Device TC1782/84, TC1746
Marking/Step BA
Package see Data Sheet

02238AERRA

This Errata Sheet describes the deviations from the current user documentation.

Figure 1 Timing concerning equidistant multiple timers

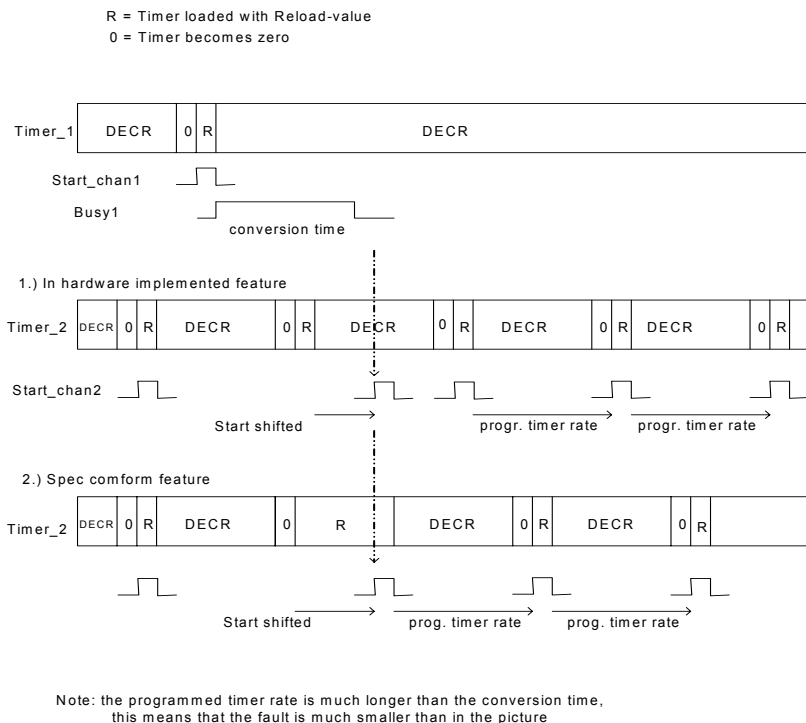
Timer_1 becomes zero and starts a conversion. Timer_2 becomes zero during this conversion is running and sets the conversion-request-bit of channel_2. At the end of the conversion for channel_1 this request initiates a start for channel_2. But the Timer_2 is reloaded only when setting the request-bit for channel_2 and is decremented during the conversion of channel_1.

The correct behavior would be a reload when the requested conversion (of channel_2) is started.

Therefore the start of conversion for channel_2 is delayed by maximum one conversion-time. After this delay it will be continued with equidistant conversion-starts. Please refer to the following figure.

Use one timer base in combination with neighboring trigger and selection by software which result has to be taken into account.

Figure 2 Alert Interrupt Behavior in case of Bus-Off

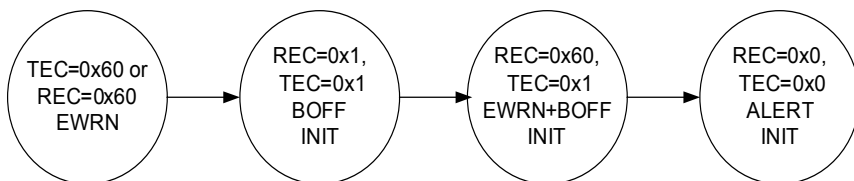
The MultiCAN module shows the following behavior in case of a bus-off status:

When the threshold for error warning (EWRN) is reached (default value of Error Warning Level EWRN = 0x60), then the EWRN interrupt is issued. The bus-off (BOFF) status is reached if $TEC > 255$ according to CAN specification, changing the MultiCAN module with REC and TEC to the same value 0x1, setting the INIT bit to 1_B, and issuing the BOFF interrupt. The bus-off recovery phase starts automatically. Every time an idle time is seen, REC is incremented. If REC = 0x60, a combined status EWRN+BOFF is reached. The corresponding interrupt can also be seen as a pre-warning interrupt, that the bus-off recovery phase will be finished soon. When the bus-off recovery phase has finished (128 times idle time have been seen on the bus), EWRN and BOFF are cleared, the ALERT interrupt bit is set and the INIT bit is still set.

Figure 3 Loss of Arbitration

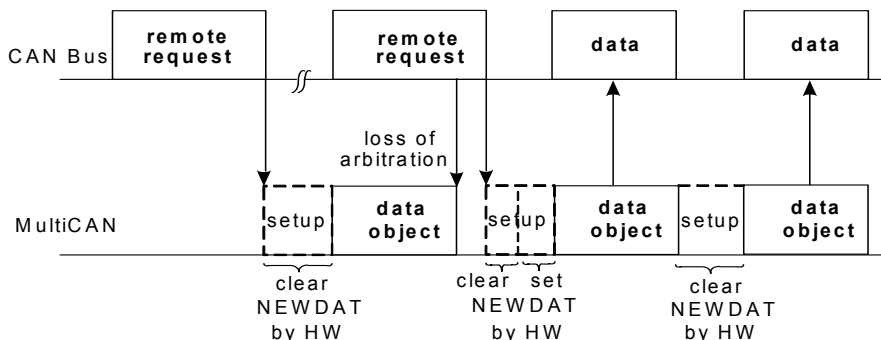
When the appropriate message object (data frame) triggered by the first remote frame wins the arbitration, it will be sent out and `NEWDAT` is not reset. This leads to an additional data frame, that will be sent by this message object (clearing `NEWDAT`).

There will, however, not be more data frames than there are corresponding remote requests.
